**R66 SERVICE LETTER SL-24**

**SUBJECT:** F642 Shaft (Engine-to-Main Gearbox) Upgrade

**ROTORCRAFT AFFECTED:** R66-series helicopters equipped with a cargo hook or agricultural sprayer and an F642-1 or F642-6 shaft. NOTE: R66 Helicopter S/Ns 0726 & subsequent were factory-fitted with an F642-7 shaft.

**FIGURE 1**

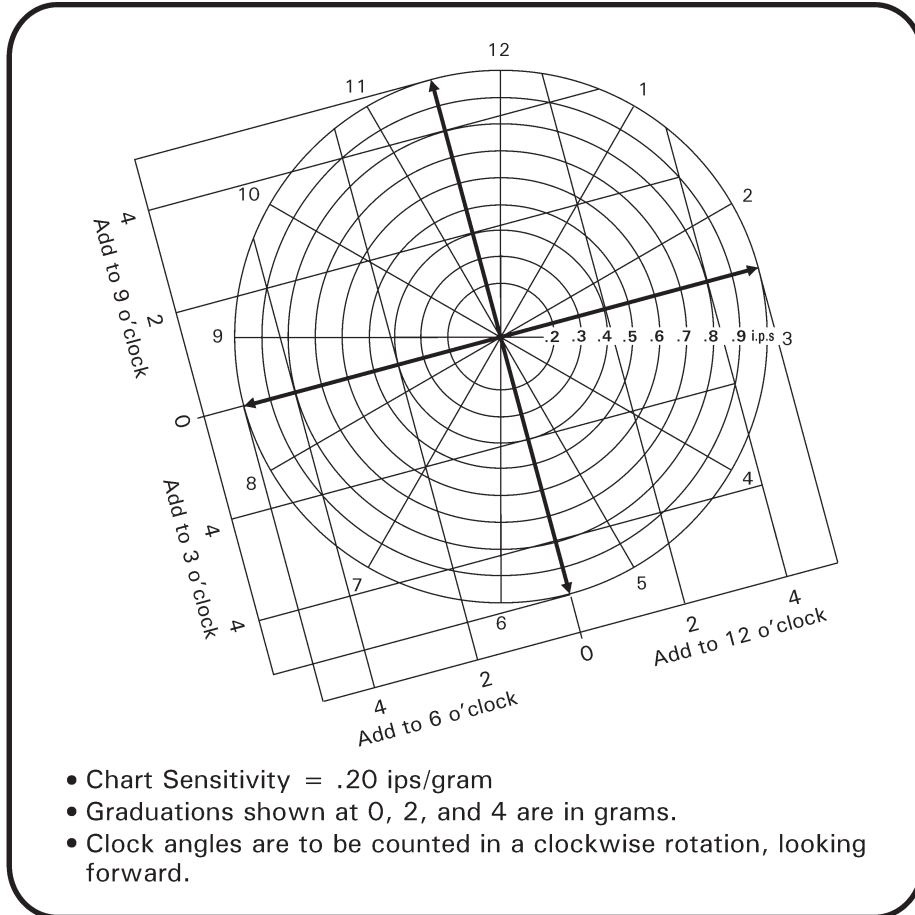
1. If helicopter is equipped with a cargo hook or agricultural sprayer and an F642-1 or F642-6 shaft, order one R9535 kit from RHC Customer Service.
2. Remove F642-1 or F642-6 shaft per R66 Maintenance Manual (MM) § 63-10 and install F642-7 shaft per MM § 63-10. See note below for new hardware included with kit.
3. Balance shaft per MM § 18-70 in conjunction with chart in Figure 1.
4. Make appropriate maintenance record entries.
